ADDITIONS & ALTERATIONS TO EXISTING RESIDENCE AT 51 CHELSEA DRIVE ON LOT 1814 OF DURBAN NORTH FOR MR MAY & MRS S.I. RAZAK

ADDITIONS AND ALTERATIONS AT 51 CHELSEA DRIVE ON 1814 DURBAN NORTH FOR THE PATON FAMILY TRUST.

Alterations and additions to approved plan 140/07/07

DEVIATION TO PLAN 140/07/07 AT 51 CHELSEA DRIVE ON 1814 DURBAN NORTH FOR THE PATON FAMILY TRUST.

List of Deviations

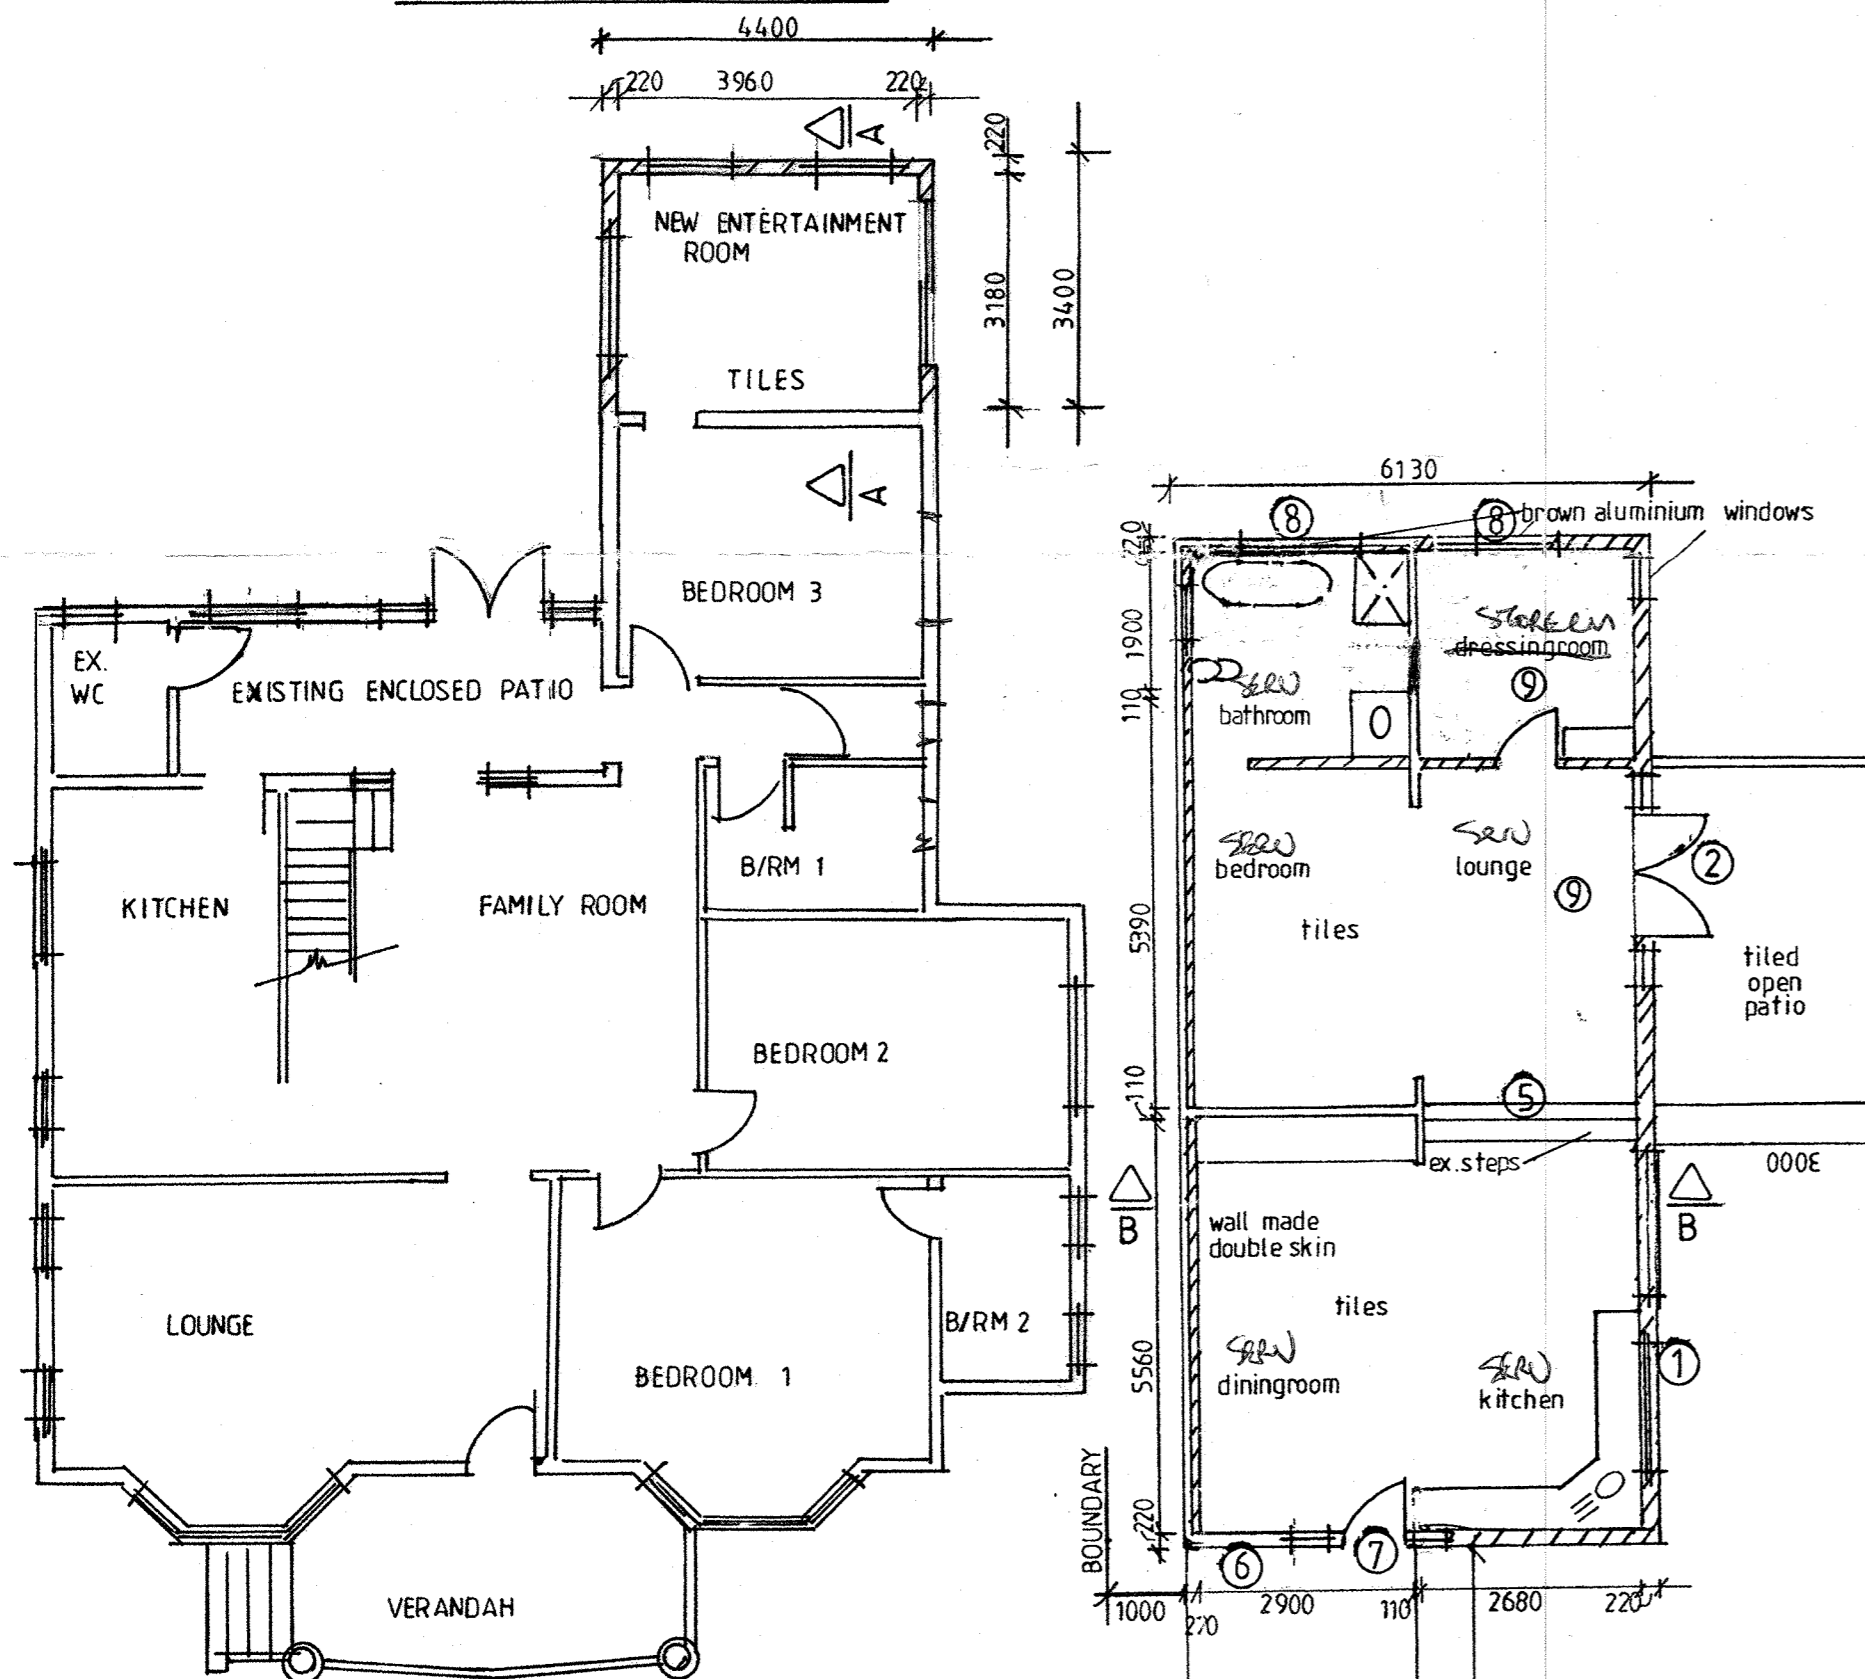
- ① Sliding door to be removed and replaced by 2 windows to new kitchen.
- ② New French doors put in new lounge.
- ③ New roof.
- ④ New chromodeck awning.
- ⑤ Ex. Steps to remain.
- ⑥ Window removed and replaced by new window.
- ⑦ New stable door and window.
- ⑧ New windows.
- ⑨ New dressing room and lounge
